Louisville and Jefferson County Metropolitan Sewer District
700 West Liberty Street
Louisville Kentucky 40203-1911
502-540-6000
www.msdlouky.org

August 17, 2012 (Revised September 20, 2012)

Subject: CSO 093 Sewer Separation
Minor Project Modification
IOAP Project No. L_SO_MF_093_S_08_A_A_0
DOJ Case No. 90-5-1-1-08254

Project Name: CSO093 Structural Modifications & Green Infrastructure

Integrated Overflow Abatement Plan
Vol. 2 - Final CSO Long Term Control Plan
 South Fork Beargrass Creek
 CSO093 Inline Storage and Increased
 Dry Flow Capacity at CSO

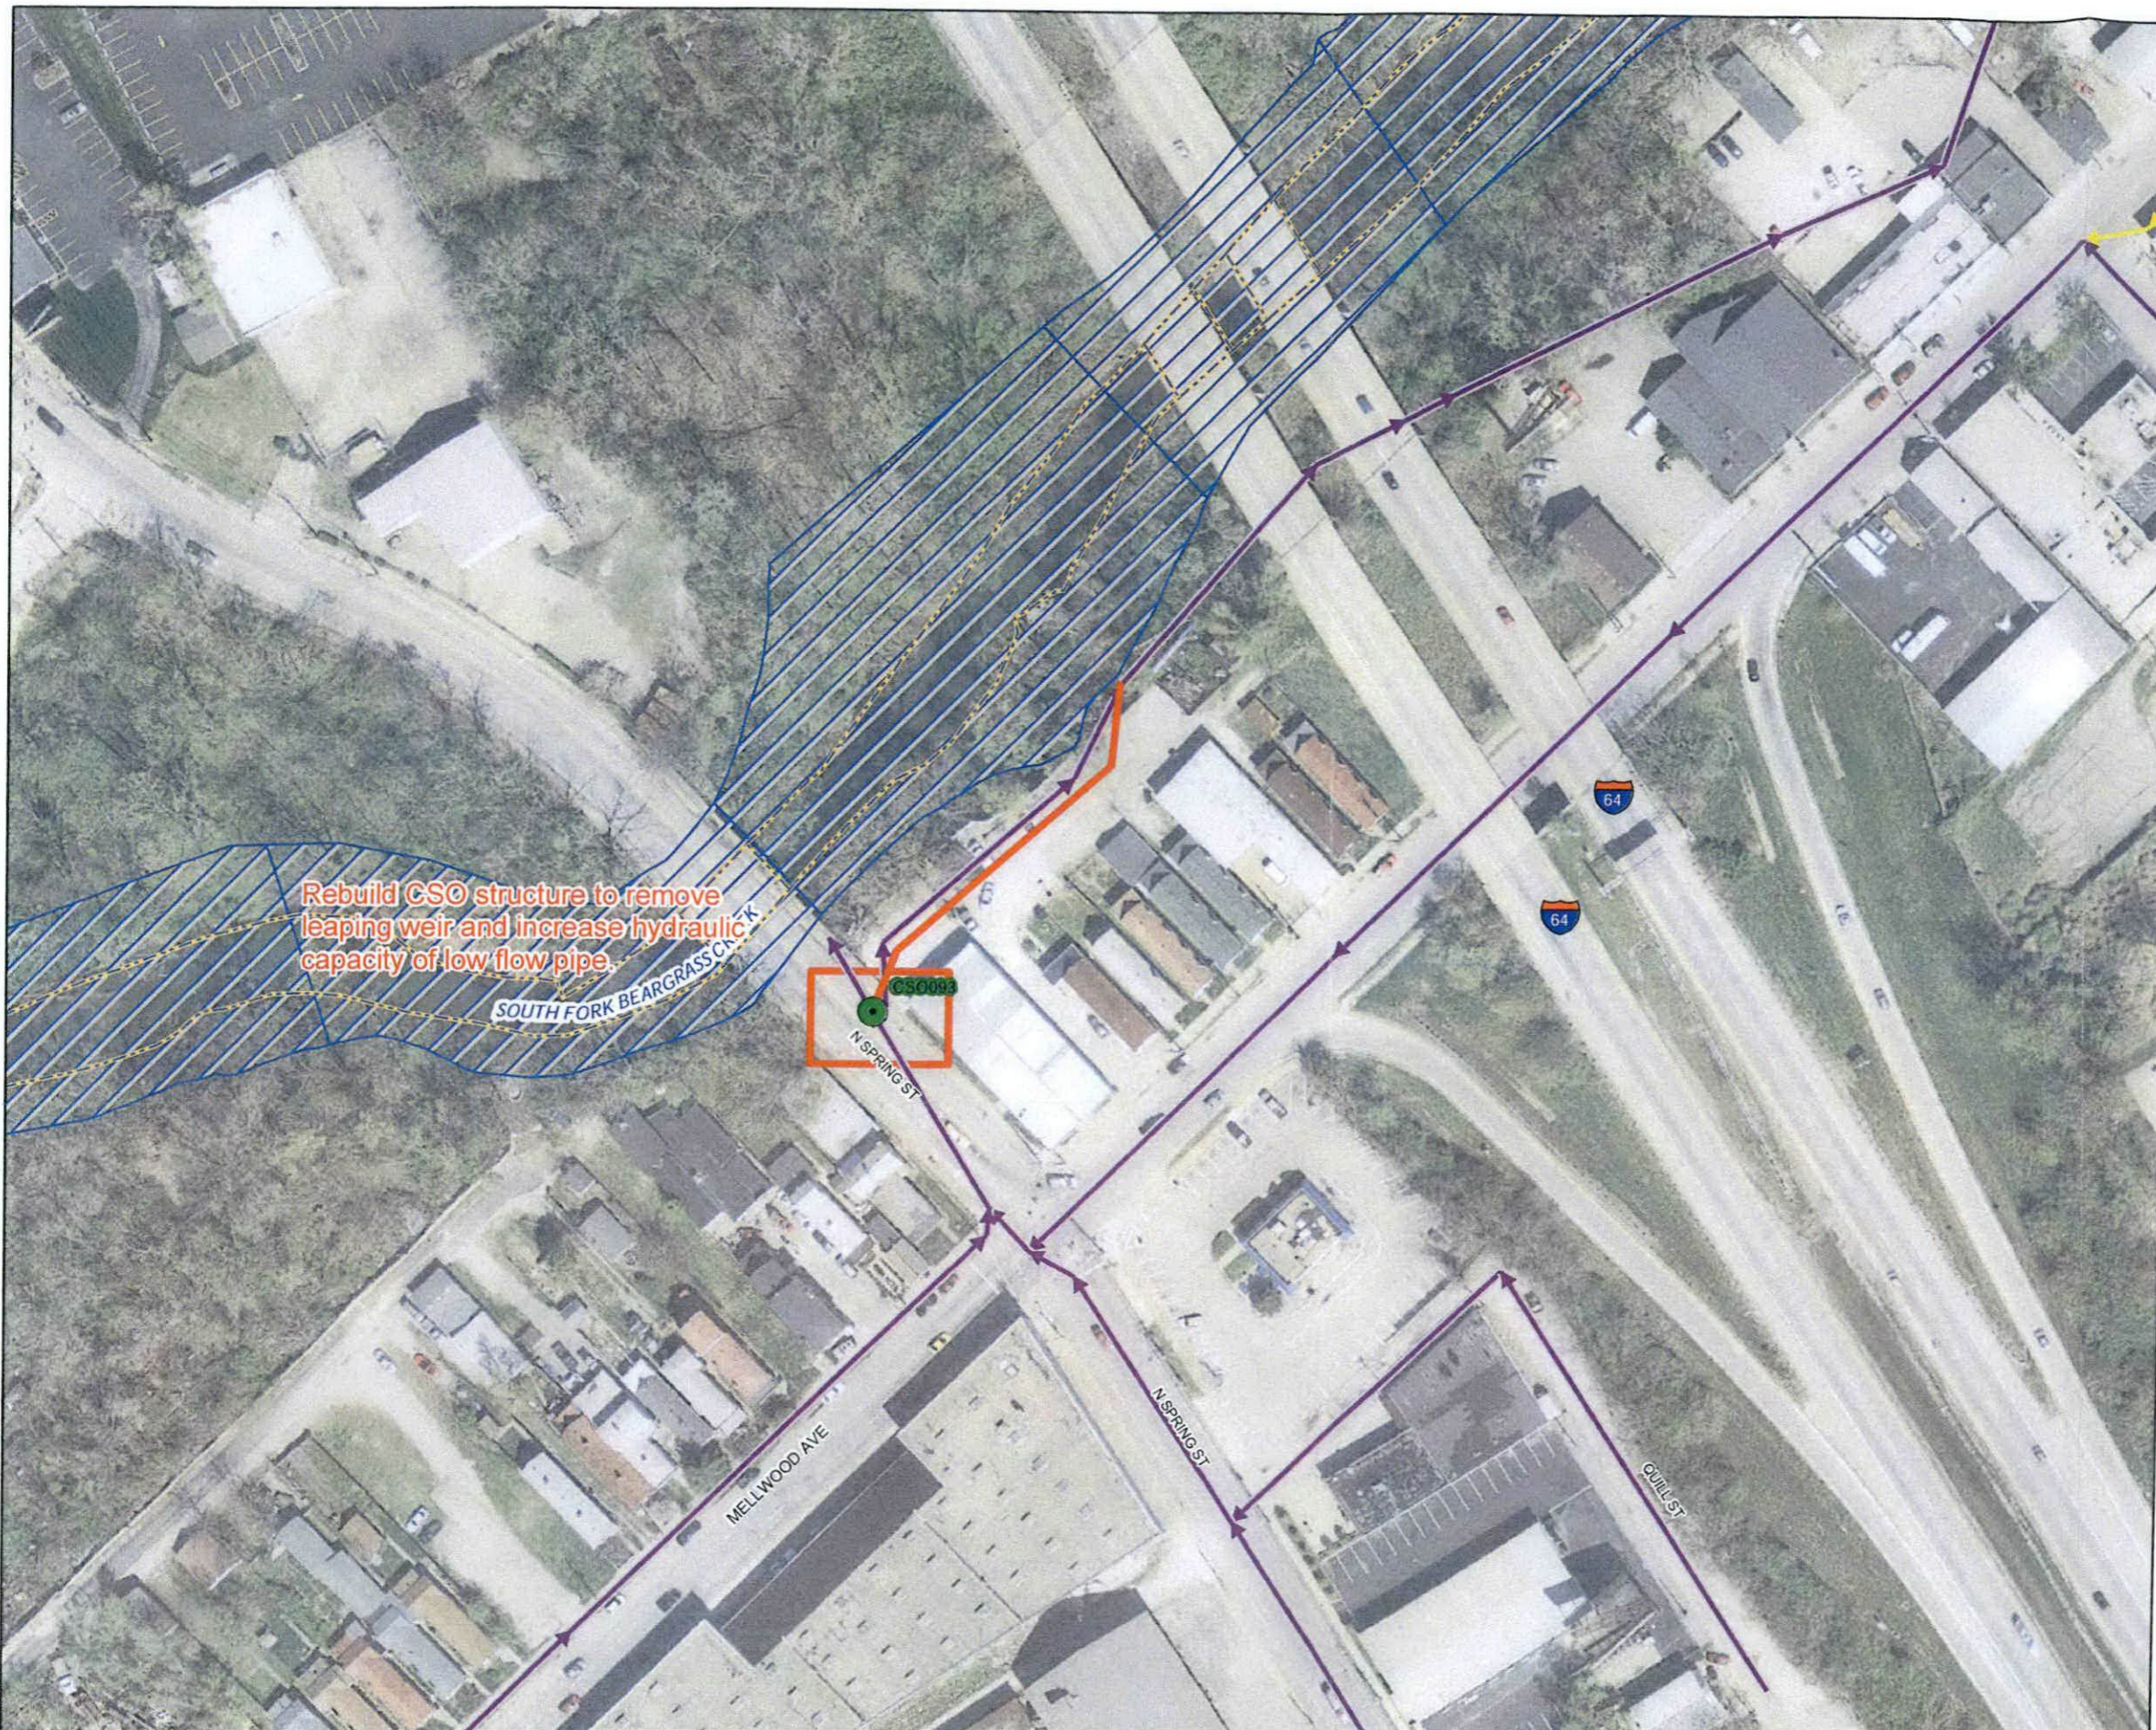
Project Description: Modify existing structure to eliminate 'leaping weir'. Implement cost effective green infrastructure practices to reinforce overflow control level. Project will reduce overflows to zero overflows in a typical year.

Rebuild CSO structure to remove leaping weir and increase hydraulic capacity of low flow pipe.
